Fan Product Change Notification

Change Notification #: PCN080323

This change affects ONLY the **09238RA series**. What has changed is that the position of the spokes were changed to standardize the casing shape and improve its rigidity.

09238RA (0 Type)

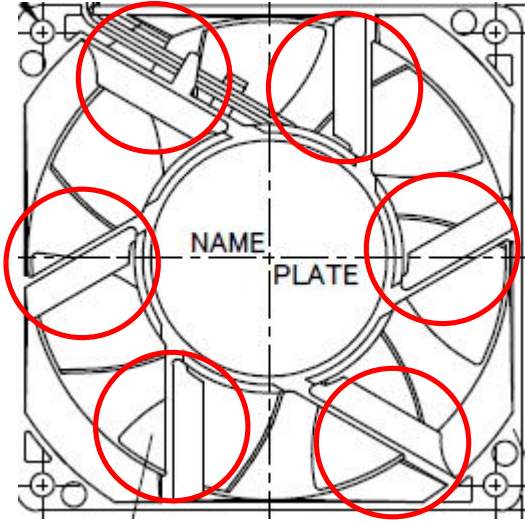
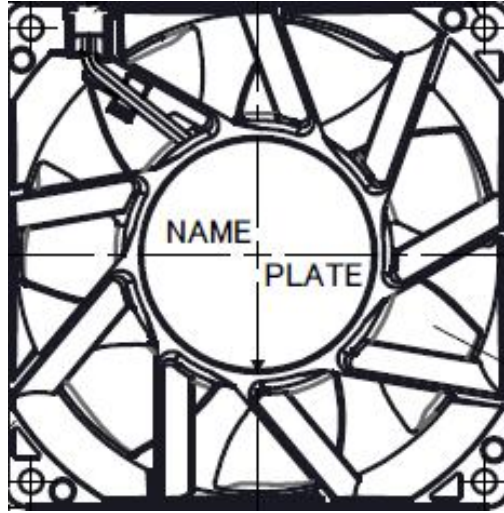
Number of spokes was increased from six (0 Type) to nine (D type) to standardize the casing shape and improve rigidity.
